Technical Service Bulletin

96 Lane change assist false vehicle warning (foil kit installation)

96 15 99 2038421/2 July 13, 2015. Supersedes Technical Service Bulletin Group 96 number 14-86 dated September 25, 2014 for reasons listed below.

Model(s)	Year	VIN Range	Vehicle-Specific Equipment
Q5	2009 - 2017	All	Not Applicable

Figure 1. Foil kit installation.

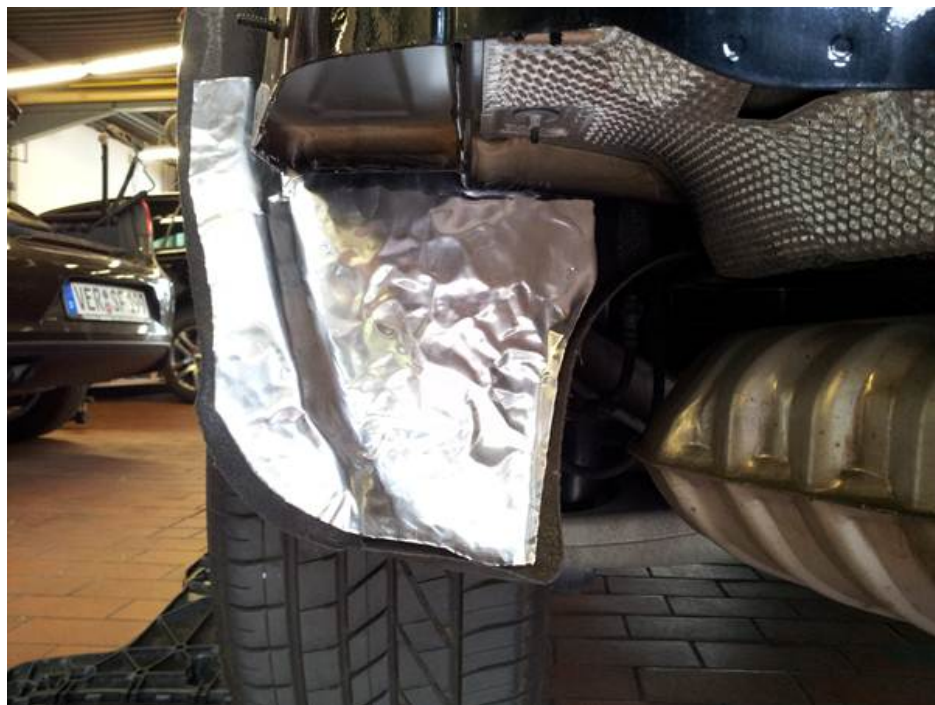
The radar is reflected from the rear wheels back to the sensors, resulting in a false side assist warning.

1. Before proceeding, verify that the side assist system is operational. If the system is not operational, if external damage is present, if components are loose, or if related faults exist, perform diagnosis and repairs outside of TSB.
2. Remove left and right rear wheel housing liners.
3. Install foil (trim foil as needed) on the left and right wheel housing liners as shown (Figure 1, Figure 2, Figure 3, and Figure 4). To ensure proper adhesion of the foil to the wheel housing liners, make sure that the fender liner is free of dirt and debris before installation.

Tip: In the following images, the rear bumper cover has been removed to show the foil installation. The cover does not need to be removed in service.
